**CITY OF HOLLYWOOD, FLORIDA
DEPARTMENT OF DEVELOPMENT SERVICES
DIVISION OF PLANNING AND URBAN DESIGN**

DATE: August 4, 2026 FILE: 25-DPJ-16

SUBJECT: First Eagle Management, LLC requests Design and Site Plan review of eight sites for a 284-dwelling-unit mixed-use development consisting of single-family, multifamily, and townhouse residential uses; a clubhouse with indoor and outdoor sports courts, ballroom, dining facilities, and 40 lodging units; Planned Development modifications; and Variances from required setbacks along internal and external streets within the proposed Planned Development (PD) Zoning District (The Club at Emerald Hills).

Figure 1: Proposed Emerald Hills Planned Development Master Plan

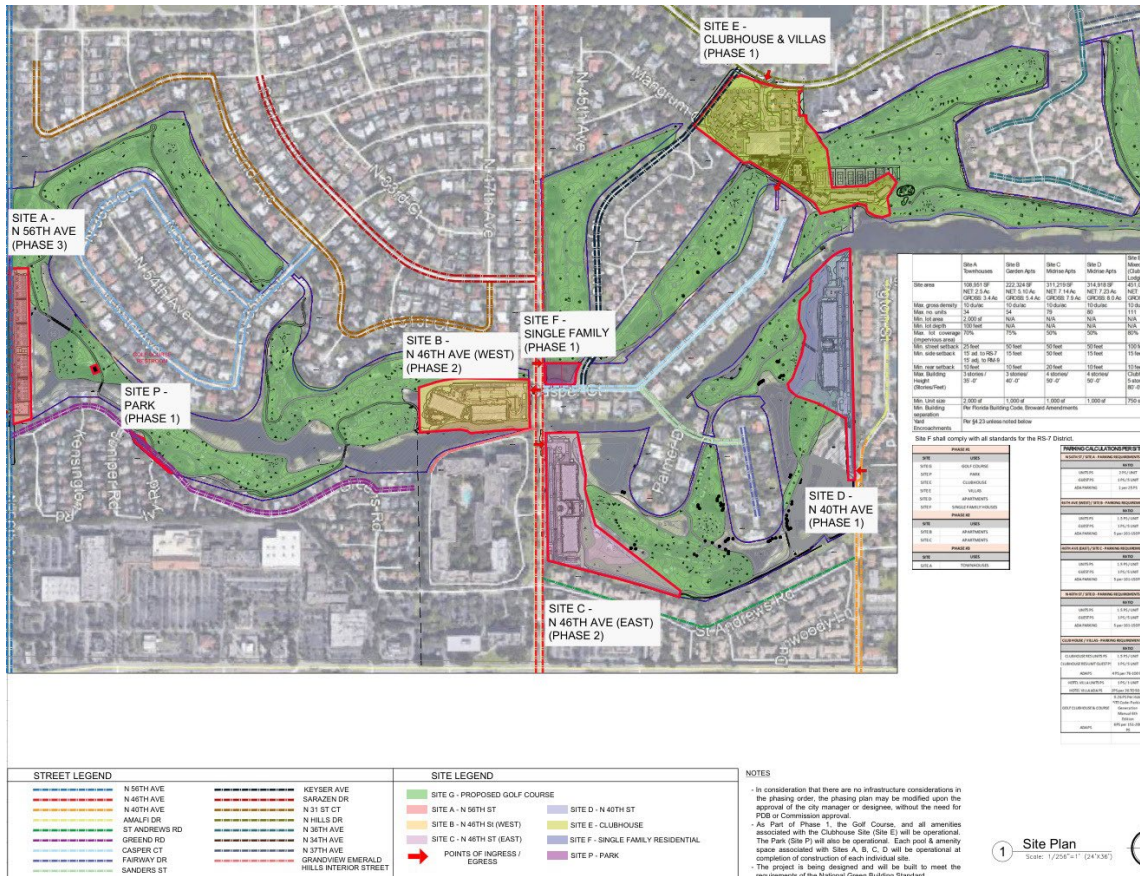
The preceding information is based on the July 16, 2026 architectural packages and June 9, 2026 PD Guidelines. Prior to City Commission consideration, the Applicant shall submit a fully reconciled plan set in which unit counts, lodging counts, parking totals, setbacks, lot areas, and plan dates are identical across the Master Plan, PD Guidelines, architectural plans, civil plans, landscape plans, traffic study, and parking documents.
